ROYAL CANADIAN AIR FORCE

MODIFICATION
RATE OF CLIMB INDICATORS

(This EO replaces 20-15-6A/1 dated 29 Feb 52)

Figure 1

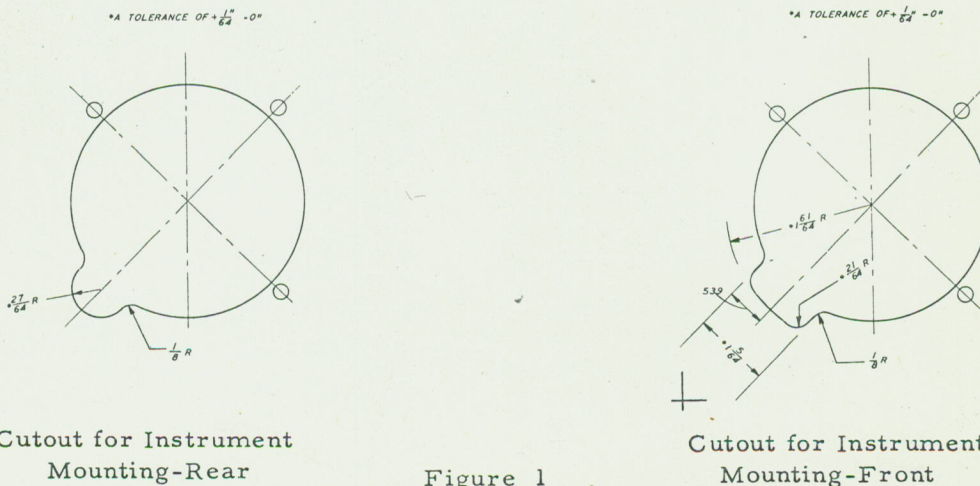
2 Installation of Indicators, Rate of Climb, Type AN 5825 will in some instances require re-working the existing panel cut-out by providing a small indent in the lower left hand corner, similar to examples shown in Figure 1, to accomodate the zero adjustment of the Indicator.
